TOWN OF PARADISE VALLEY

Kachina Estates Subdivision Sign & Modified Subdivision Wall (MI-17-02)

Town Council
October 12, 2017

SITE PLAN

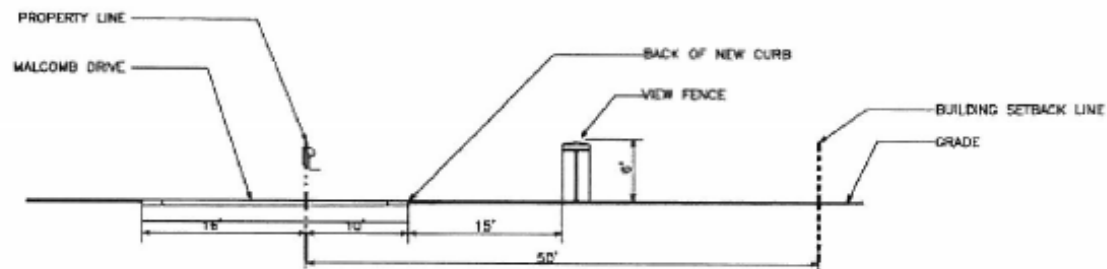
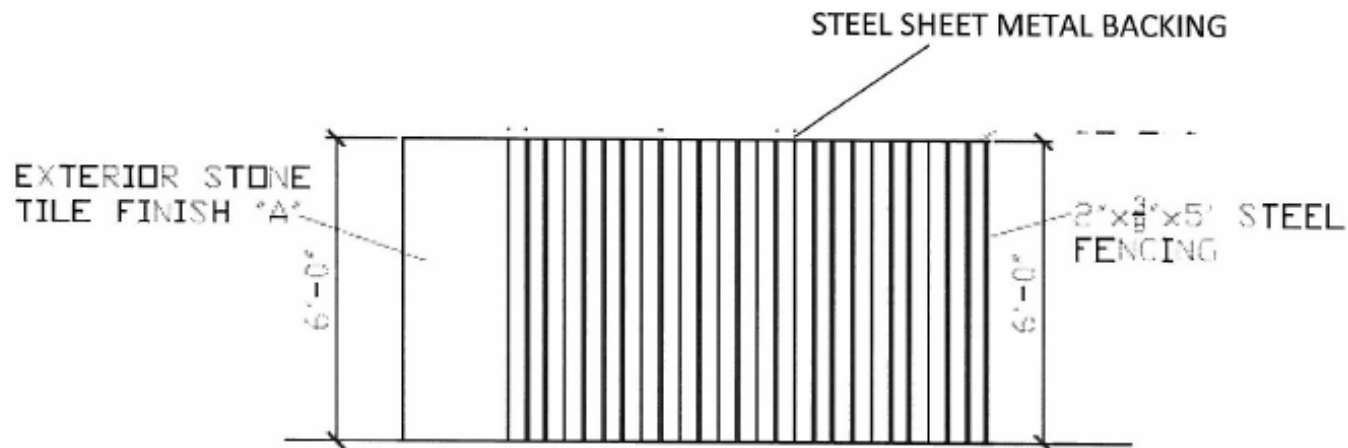
- Staff supportive of sign:
 - Sign not illuminated and only one sign
- Staff not supportive of fence wall screening:
 - Does not meet intent of original Council approval
 - Originally approved with 25' roadway easement (in lieu of ROW dedication)
 - Approved with view fence in order to preserve and maintain visual openness
 - Screening eliminates visual openness and increases presence or massing of fence

- Staff recommends approval of sign and denial of adding fence screens
- Should Council wish to approve application, sign and fence screens shall be in substantial compliance with plans and docs
